WATER PERMIT NO. 2873-2

**SOUTH DAKOTA
WATER PERMIT NO. 2873-2**

**RECOMMENDATION OF CHIEF ENGINEER FOR WATER PERMIT
APPLICATION NO. 2873-2, Joseph Kuhlman**

Report to the Chief Engineer
On Water Permit Application No. 2873-2

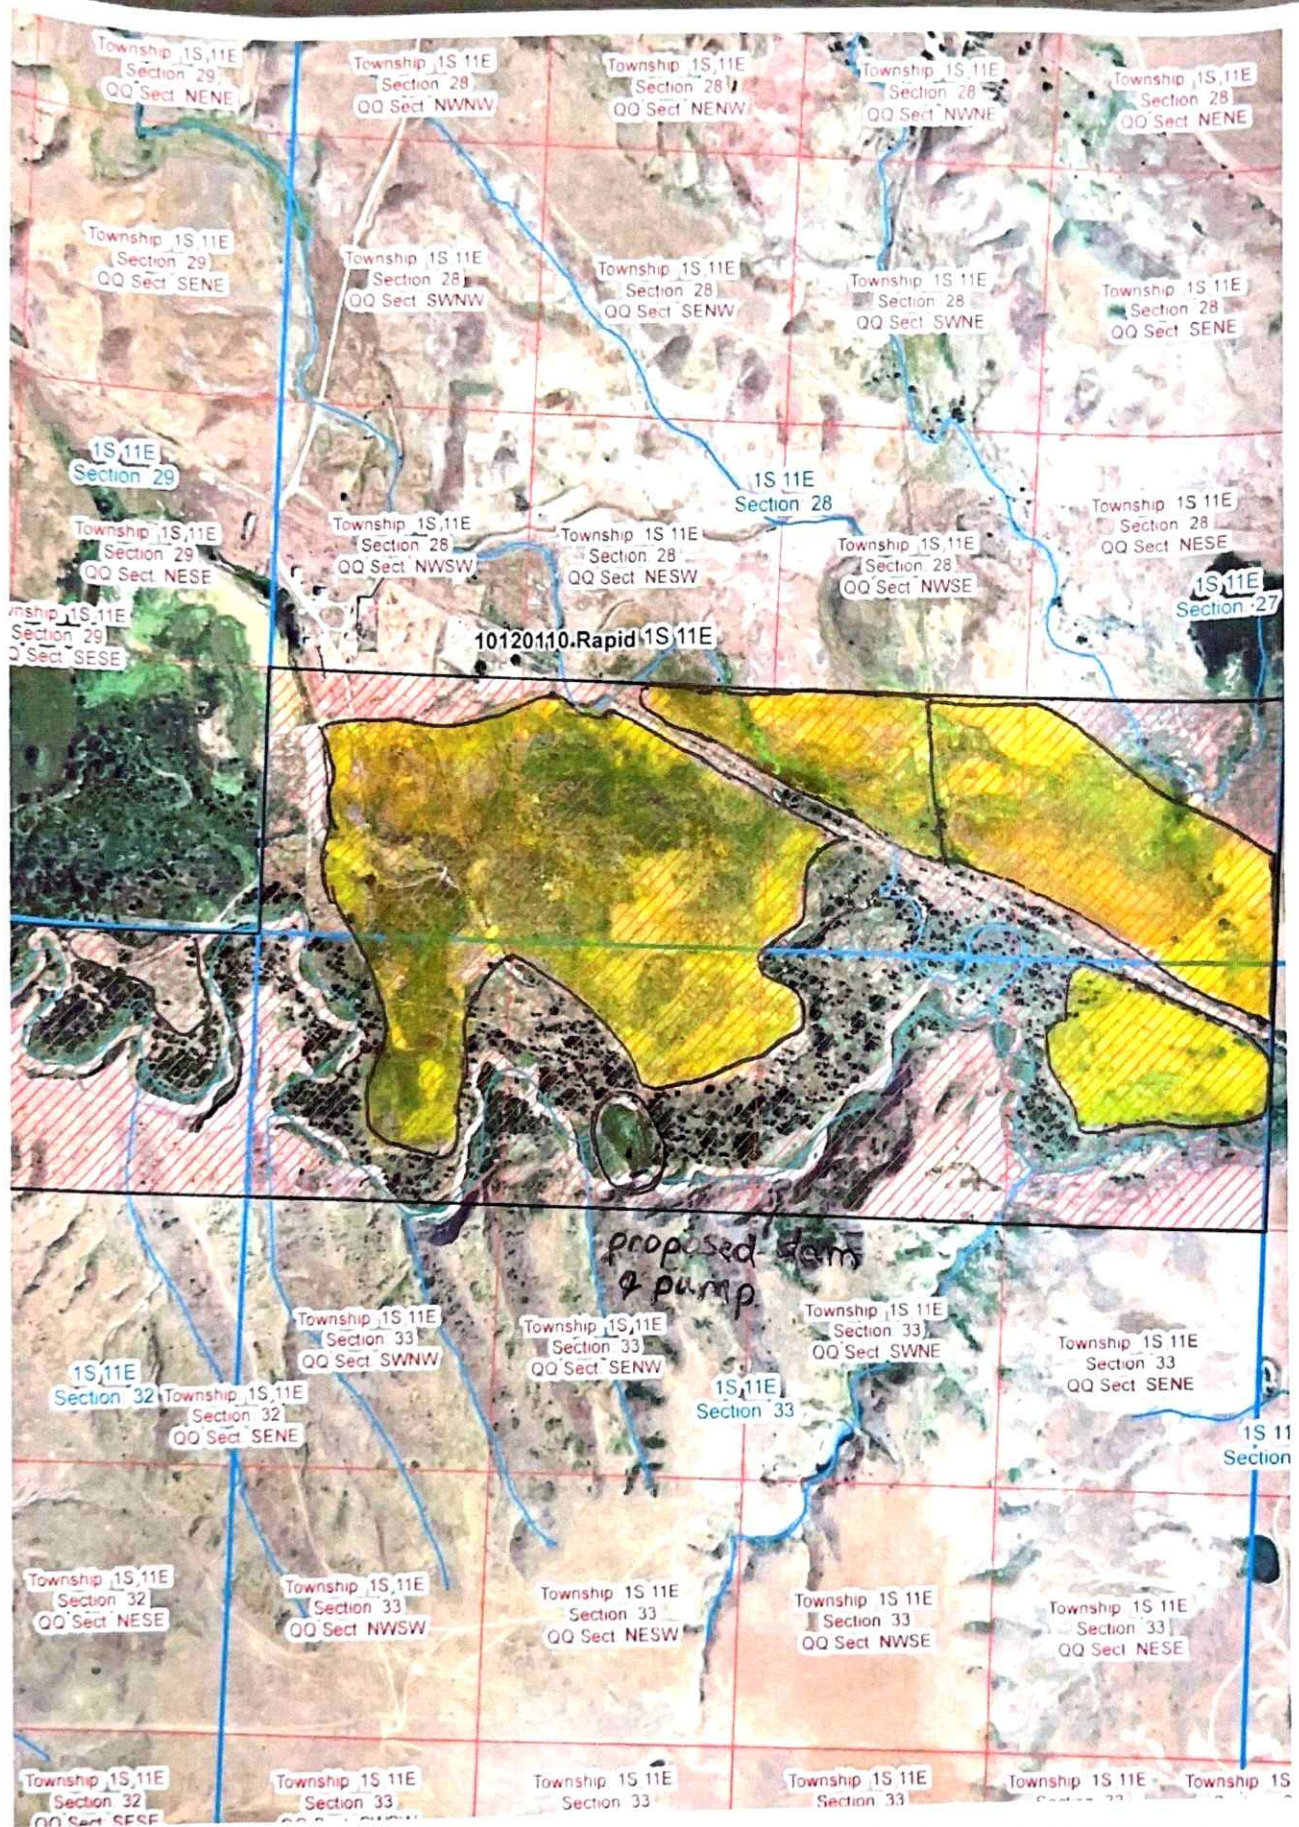
Thanks for your quick response. Yes, you have answered all my questions. However, the sheet you submitted, see attached, has 12 acres in the NE ¼ NE 1/4 Section 32-T1S-R11E and the map you returned does not include these 12 acres. Please let me know if you plan on irrigating these 12 acres or not.

1. Attached is a map –
 1. please mark the location of the dam – is it on the creek or beside the creek
 2. mark the location where you plan to pump from the creek
 3. Is the crosshatched section in bright red the irrigation area? If not, please mark the area to be irrigated.
2. The fee for irrigating 237 acres is $\$950 + \$200 = \$1,150.00$. You submitted $\$1,050.00$, please submit the additional $\$100$.

Good question, I was going to but now I am not mainly just for ease of fencing for cattle it will not work to irrigate that parcel.

- 1). The location of the proposed dam will be by the creek. Rapid Creek used to make a "U" but in 2018 it washed through and now goes straight across and no longer flows around the "U" in the creek. I believe I had it marked on the map. It's hard to explain so I hope this explanation helps. I can resend another map with the additional check to further clarify location.
- 2). The pump would go basically in the same location as the dam or extremely close too. Both dam location and pump location is about directly in the middle of our proposed irrigated farmground so this location would work well for us.
- 3). Yes the highlighted section is most of our irrigated farmground but not all. I will try another way to map that out for you.
- 4). Can you let me know if this clarifies things before I send the additional paperwork back to you.

I am sorry but I did see your map that was attached at first. I hope this helps explain from my earlier email. Yellow is irrigated ground and the "circled" part is the dam or pump location.
